Technical Service Bulletin

WARNING MESSAGE FOR DIRT ON FRONT RADAR SENSOR SURFACE APPEARS WHILE DRIVING IN SPECIFIC LOCATION

Bulletin No.: 15-001/23

Case	Road conditions	Image
1	Roads with continuous elevated road ways on one side or tall walls on one s ide

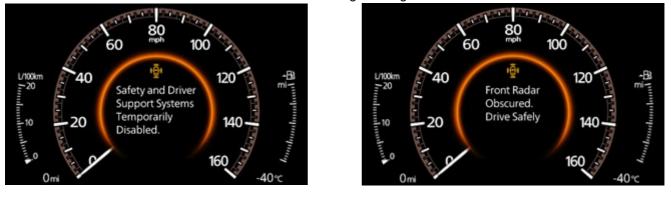
Some vehicles may exhibit the warning messages "Safety and Driver Support Systems Temporarily Disabled" or "Front Radar Obscured. Drive Safely." displayed in the instrument cluster despite no dirt on the front radar sensor while driving in specific locations as follows:

This is caused by inappropriate decision logic of the control software in the front radar sensor. To eliminate this concern, the control software of the front radar sensor has been modified.

2. Replace the front radar sensor with a modified one according to the instructions on MGSS.
